DESIGN REVIEW BOARD – URBAN DESIGN PANEL

**Planning Staff Report to
Design Review Board - Urban
February 26, 2021**
for the March 4, 2021 Public Hearing

CA 20-775 • 330 WOODRUFF ROAD

6 NEW ELEVATOR TOWER SECTION
1/4" = 1'-0"

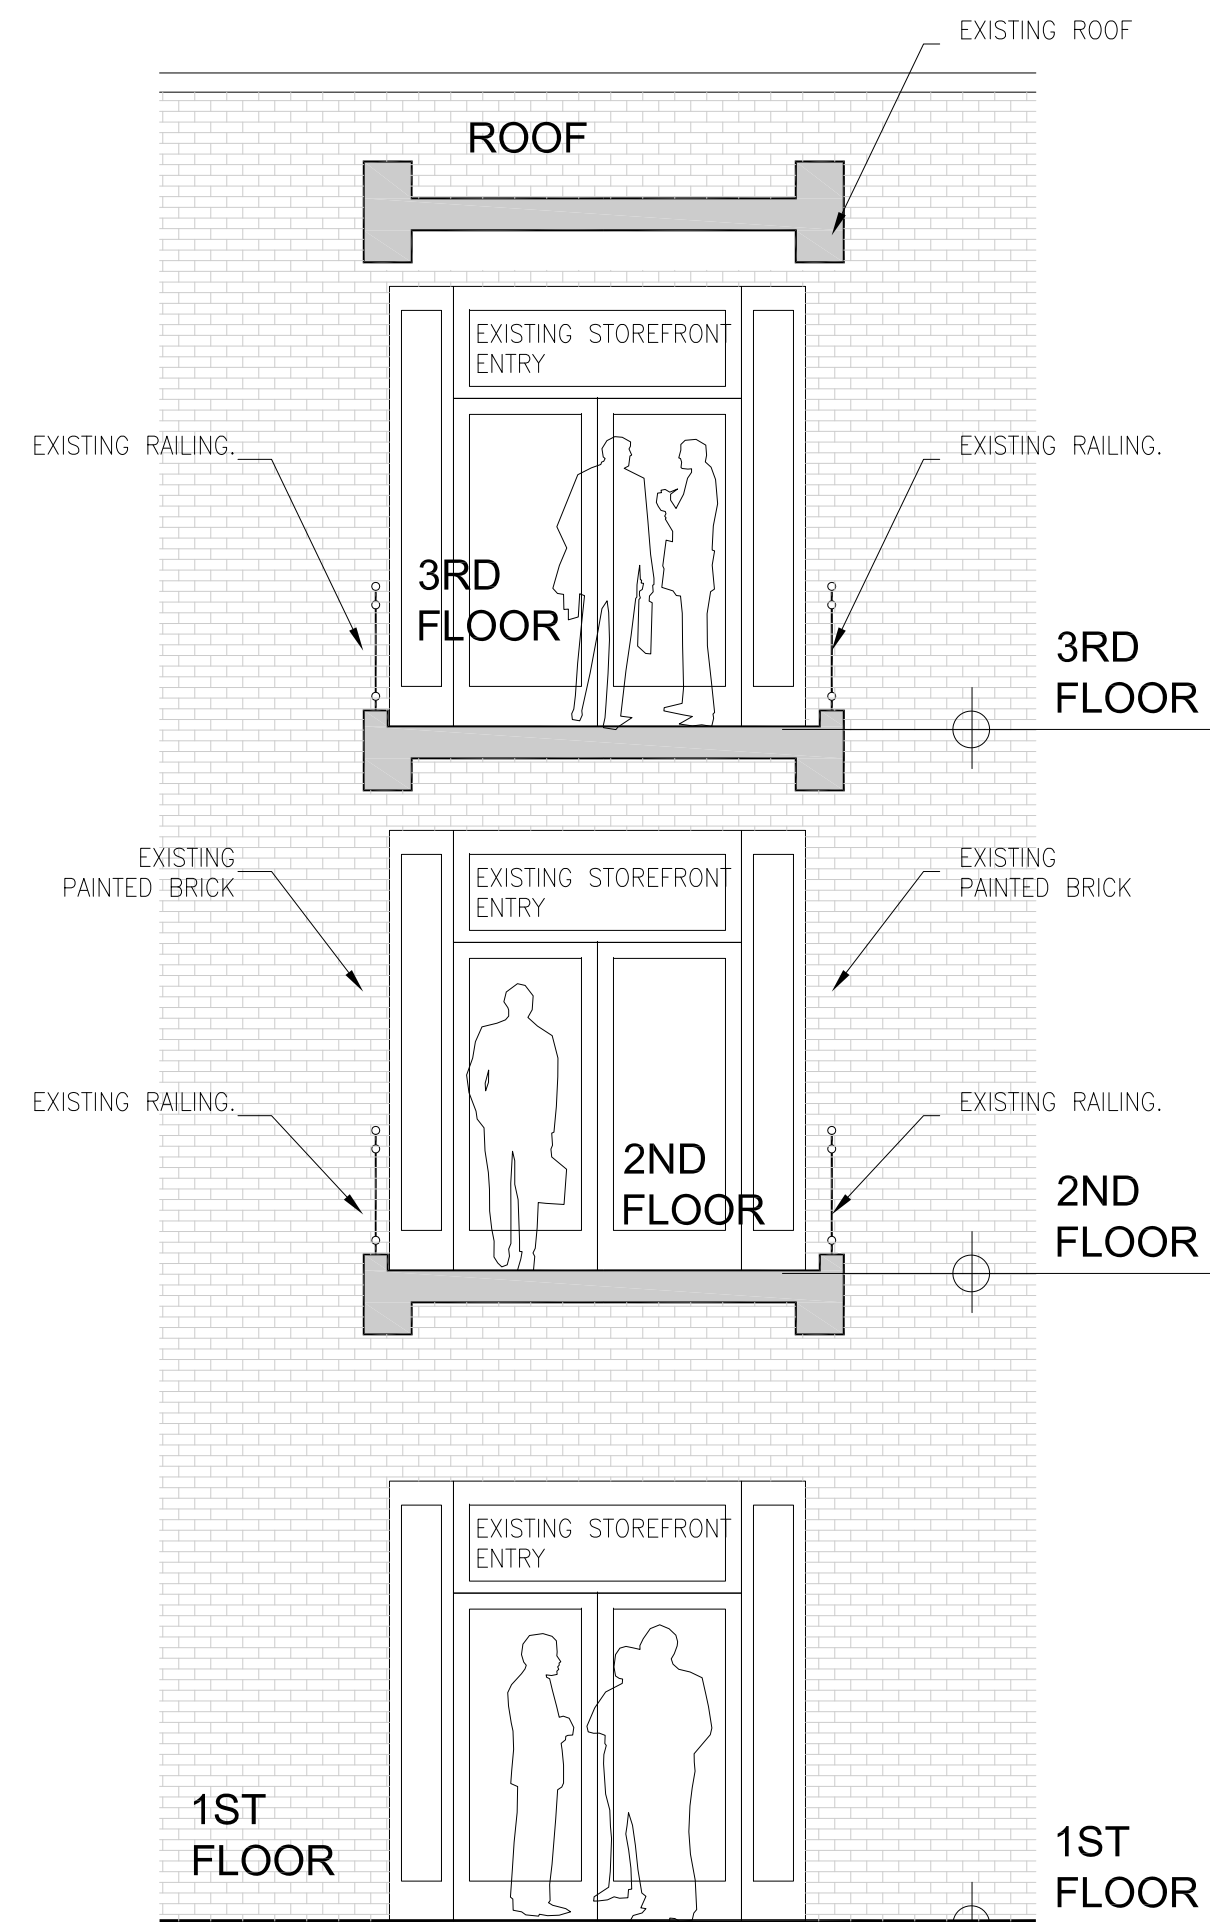
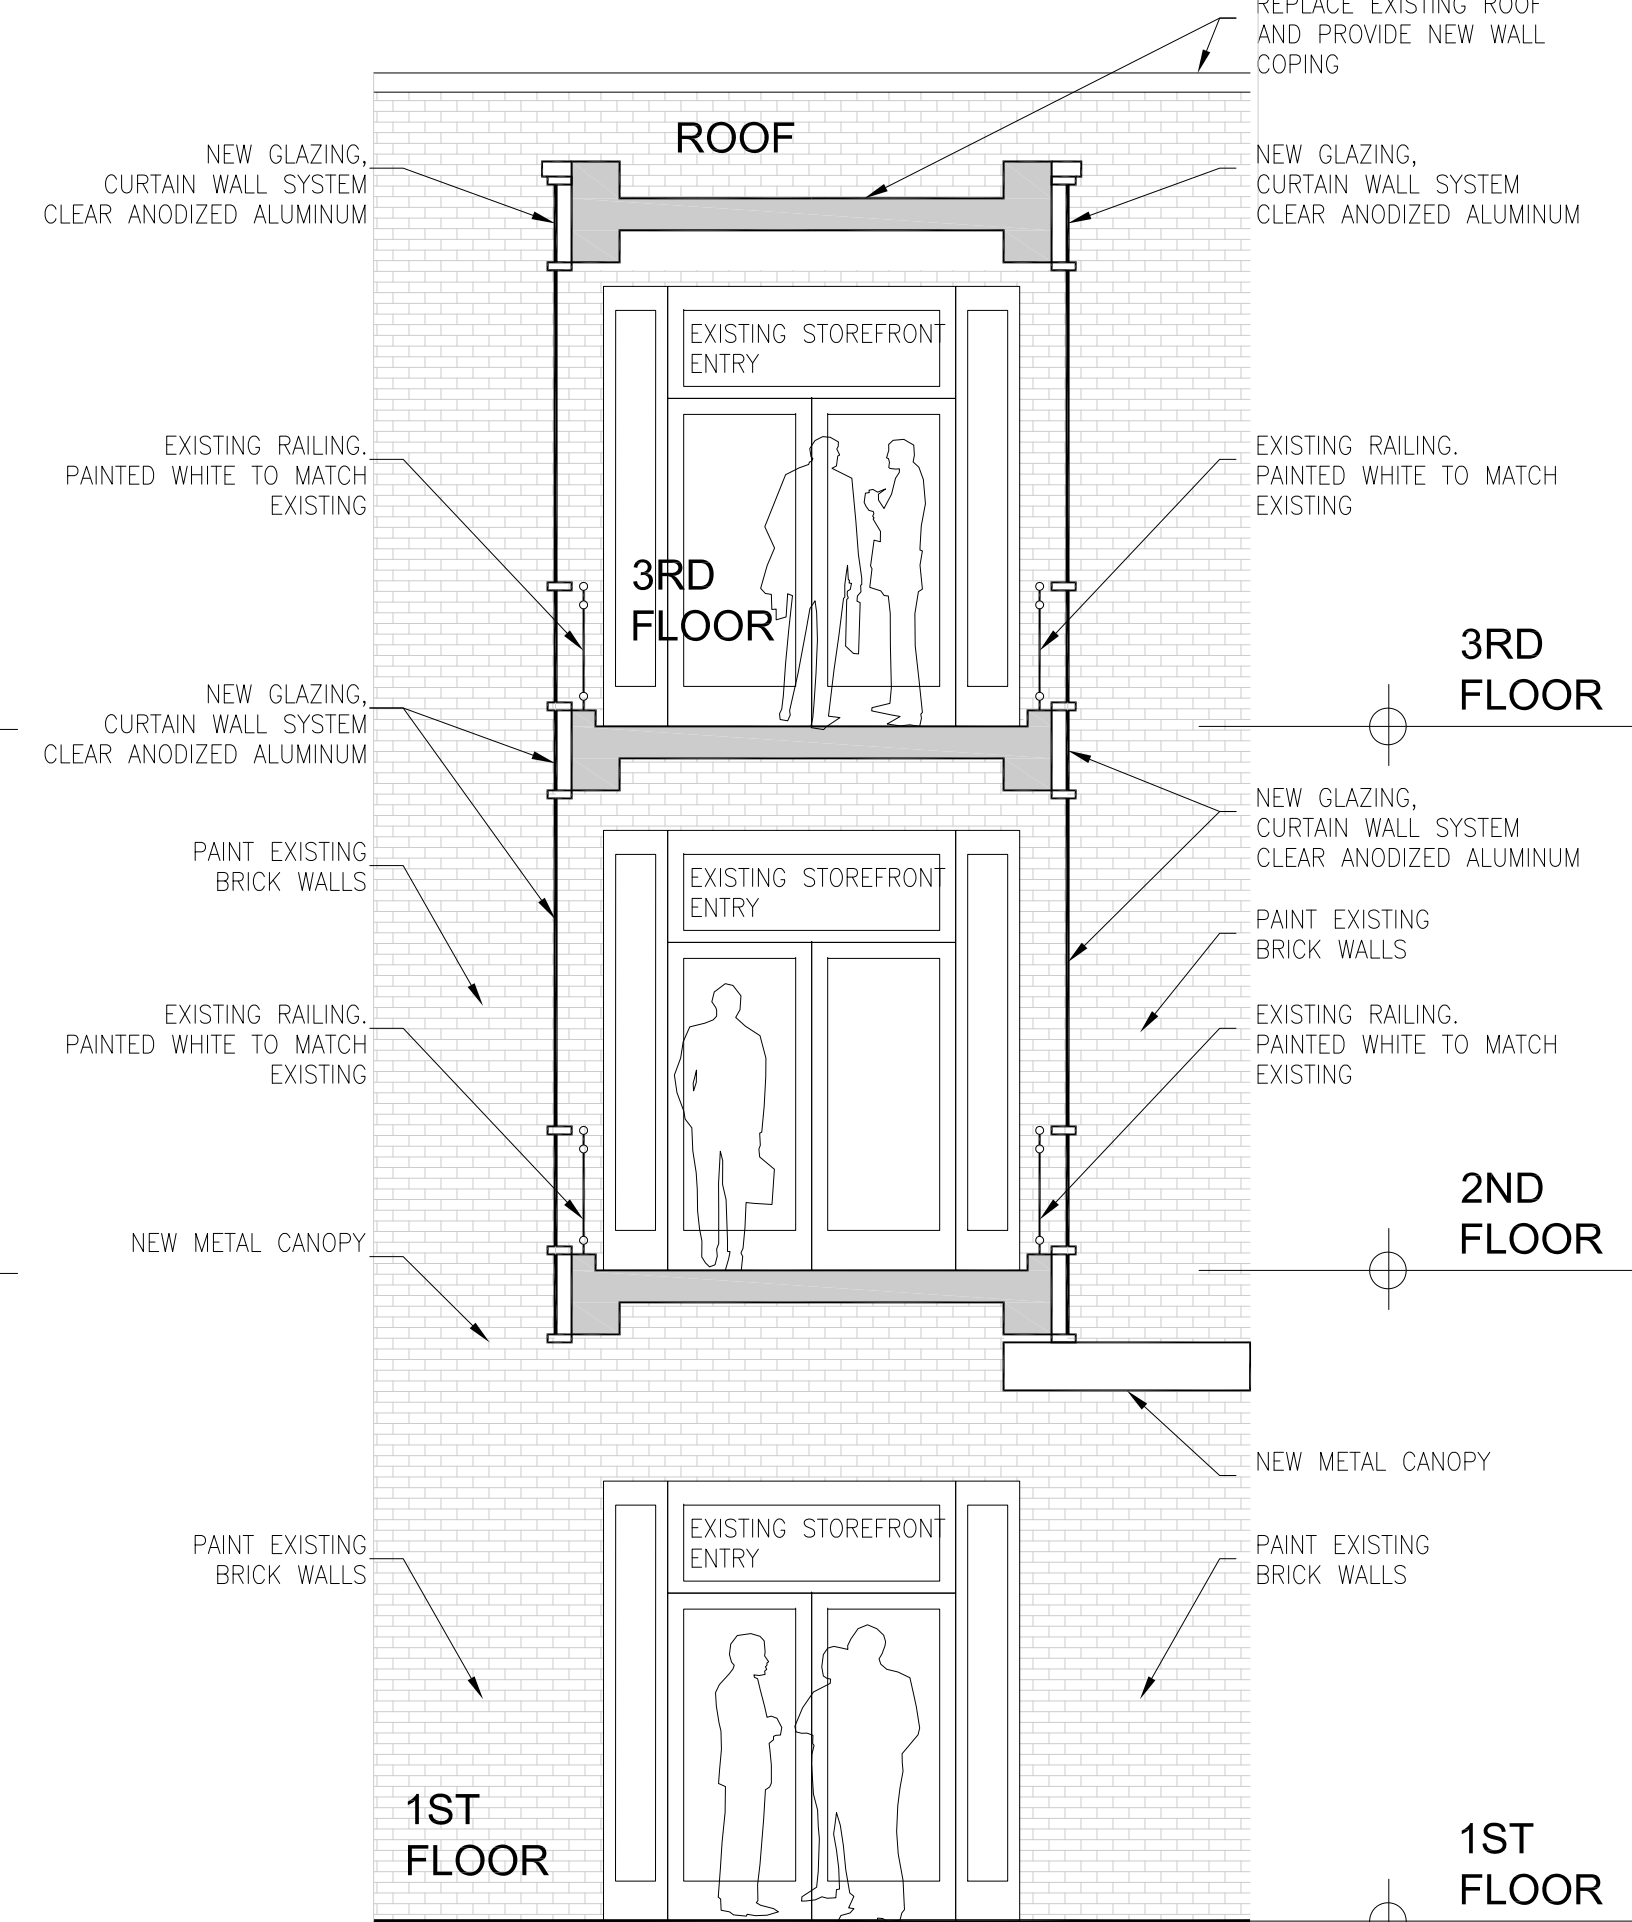
The elevator and stair tower were an addition to the building believed to have been constructed in the late 1980s for accessibility. This project proposal redesigns the tower to be partially enclosed with glass and to change the roof to a flat design. In addition, the design incorporates a blue band that extends down to the planned canopy. Lastly, the tower walls will be used for wall signage for the new tenant, Truilant Federal Credit Union.

4. A detail of the canopy ceiling shall be submitted to staff and reviewed and approved by a two-member committee of the DRB.
5. As this building is listed within the City's historic resources survey, construction shall be executed to the Secretary of the Interior's standards. This includes the attachment of the projecting sign and canopies to the building through the mortar joints and not through the existing brick.
